SERVICE BULLETIN

SERVICE BULLETIN		No.: MSB-98E00-503		
		Date: 1998-12-15		
Subject:	CORRECTION TO DIAGNOSIS CODE READING PROCEDURE FOLLOWED WHEN USING WARNING LAMP		<Model>	<M/Y>
			(EC,EXP)COLT	96-10
			(CA0A,CC0A)	97-10
			(EC,EXP)	97-10
Group:	GENERAL	Draft No.: 98AL051414		
CORRECTION	OVERSEAS SERVICE DEPT	 T.NITTA - VICE GENERAL MANAGER QUALITY INFORMATION ANALYSIS	GALANTE (E50-80)	96-10
			(EC,EXP)L200(K00)	
			(EC,EXP)LANCER	
			(CB0A,CD0A)

This Service Bulletin informs you of correction to the diagnosis code reading procedure to be followed when using the warning lamp.

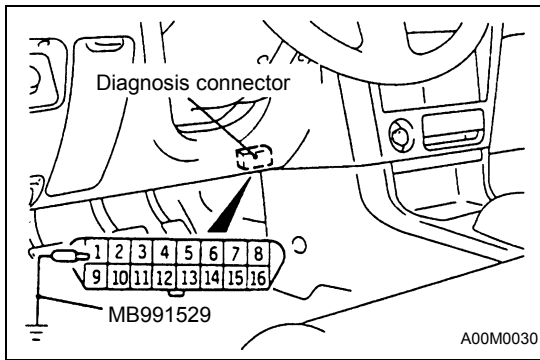
<Incorrect>

3. Turn off the ignition switch.
4. Read out a diagnosis code by observing how the warning lamp flashes.

ON <Correct>
